# Manual 12, Balancing Operations

System Operations Subcommittee  
September 2, 2026

## **Revision 58 (12/01/2026): Confirming Changes to Regulation Redesign Phase II**

**Manual 12, Rev 58 – Regulation Redesign Phase 2**

Exhibit 3: Resource-Dispatching

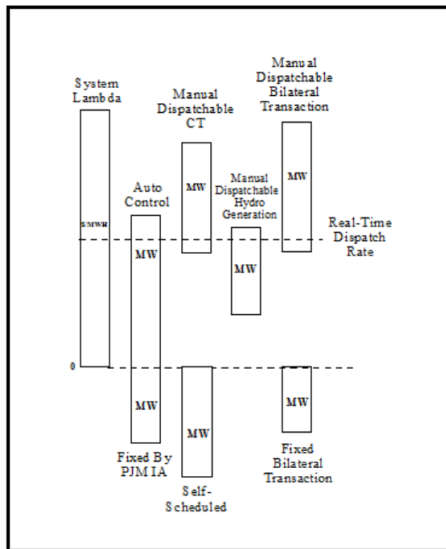
- Removed Resource Dispatching Exhibit and Regulation Assignment Exhibit as these exhibits are not relevant anymore.

Exhibit 5: PJM Member Interface

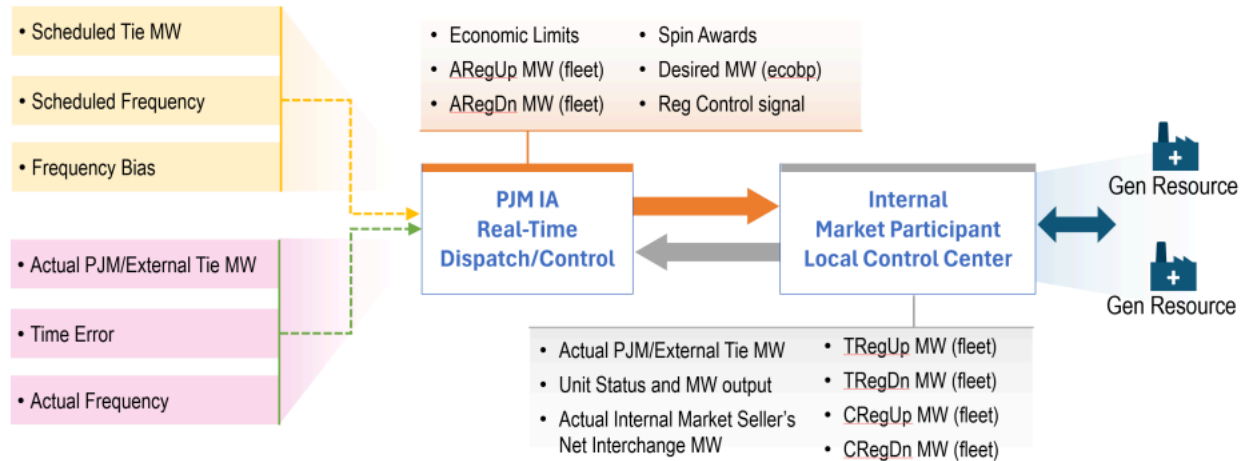
- Updated PJM Member Interface Exhibit and Assigned Regulation Exhibit to accommodate RegUp and RegDn.
